Addendum #3

City of Fruita
Bid Schedule
19 Road Improvement Project - Addendum 3
Project No. 130-750-77-4730

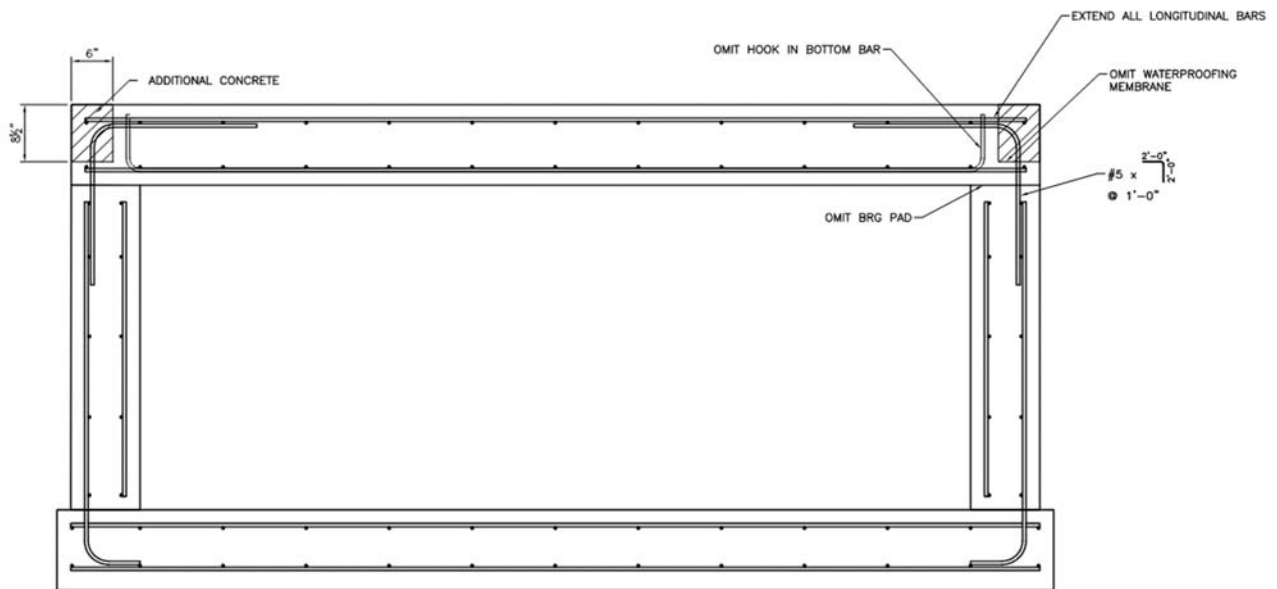
Q1:-I noticed question 12 in addendum #2 asked about pre-stressed which is not the same as pre-cast. The SGM drawings show a series of precast lids for the concrete box culvert. My question is it an acceptable option to pour the entire concrete box culvert as cast-in-place and eliminate the precast lid sections in doing so?

A: A cast in place top slab may be used in place of the precast slabs shown in the plans. If this option is selected by the contractor there will be additional concrete and reinforcing steel that will not be measured and paid for. The detail below shows the additional corner bars, and changes to the top and bottom bars as well as the location of additional concrete. The bearing pad and waterproofing membrane and hooks on the #6 bar may be omitted. The deck joint detail on sheet S6 is no longer necessary if this option is selected. The top of the wingwalls and headwalls must be placed at the same time as the top slab. The deck must be placed in more than one pour to minimize shrinkage. If this is selected SGM will work with the contractor to determine the locations of the construction joints. SEE BELOW DIAGRAM:
